Report to the Future Melbourne (Planning) Committee

Agenda item 6.2

**Planning Permit Application: TP-2019-342
10-16 McKillop Street, Melbourne**

15 October 2019

Figure 6a – Extent of overshadowing at April 22 at 11am

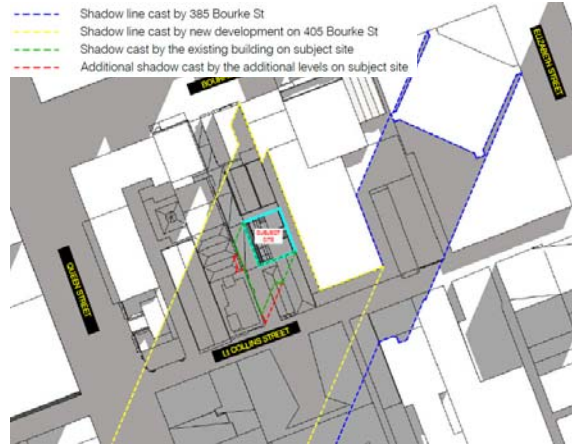
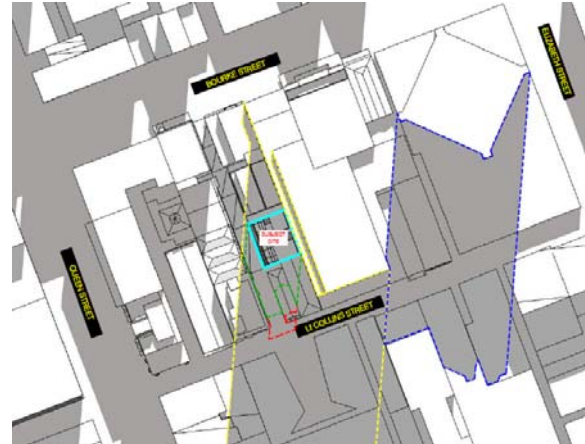
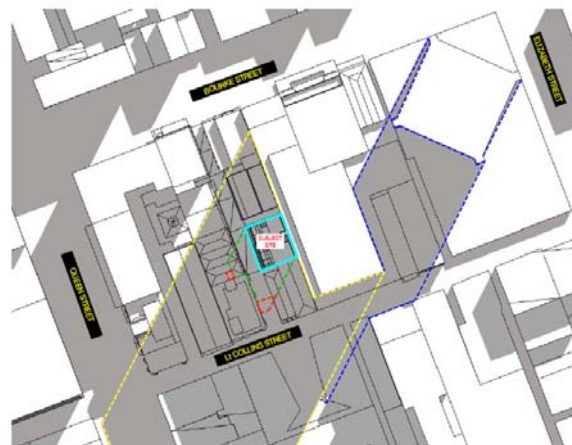
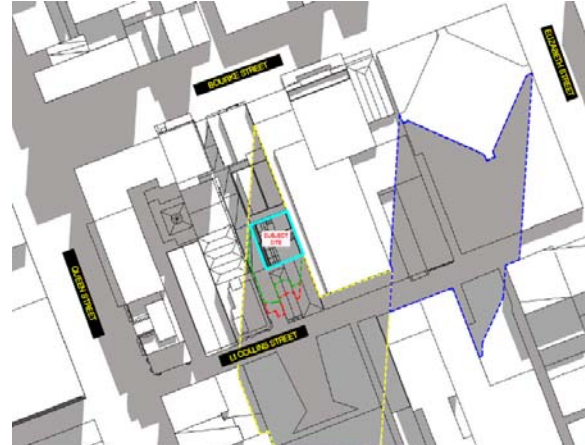
As demonstrated in figures 6a-d below, the proposal will not result in any additional overshadowing, as any shadow created by the proposal will be surpassed by larger development to the east of the site.

Figure 7 – Sightline diagrams

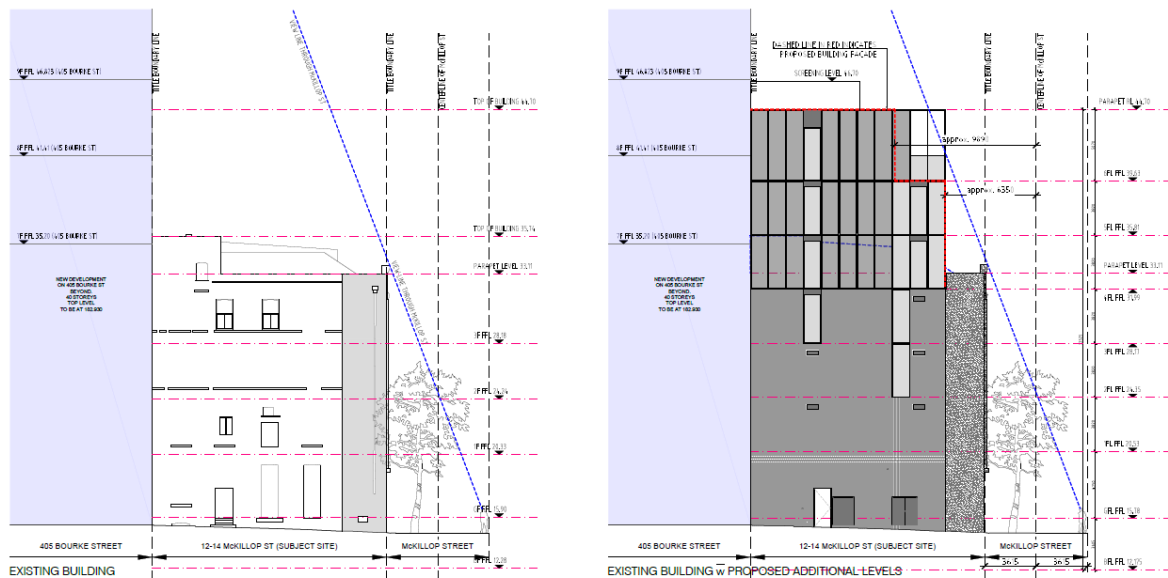
- The additional three storeys will be setback 2.7 metres and 6.2 metres from the frontage and will not be immediately discernible to users of McKillop Street as illustrated in figure 7 below.

Figure 8 – Building heights in immediate context

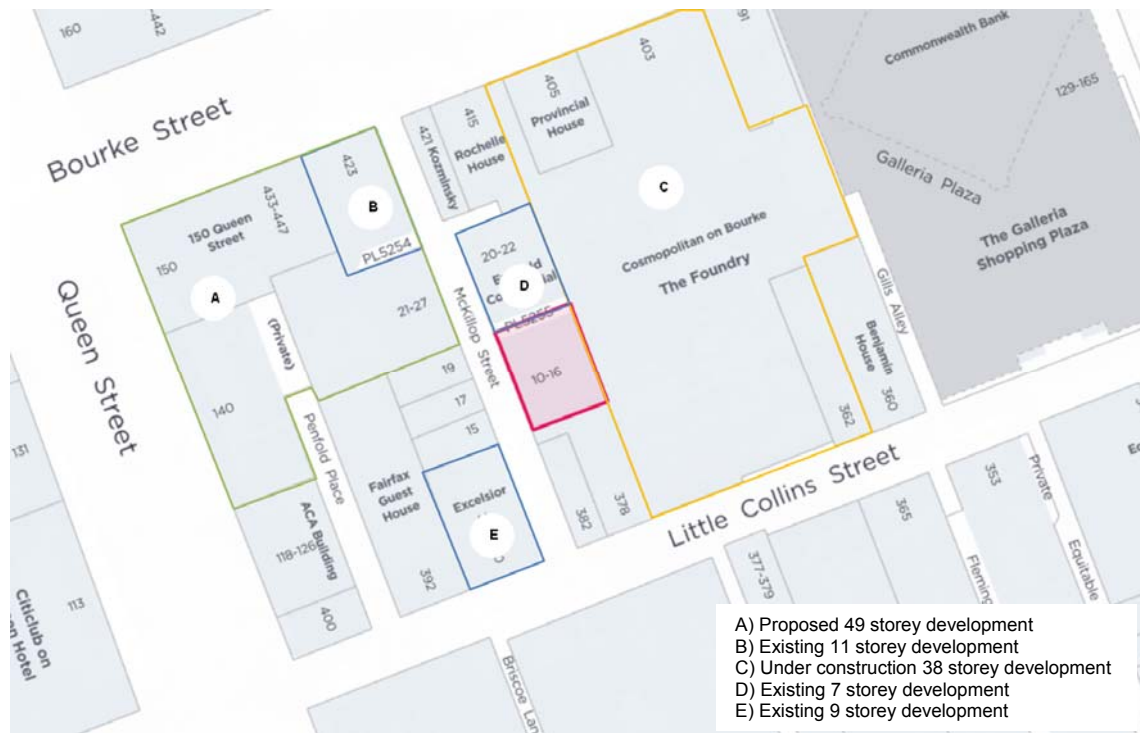
- As illustrated in figure 8 overleaf, Ministerial approval has been granted for the adjoining site to the east at 405 Bourke Street (approved under PA2012/005554) for a 38 storey building upon completion.
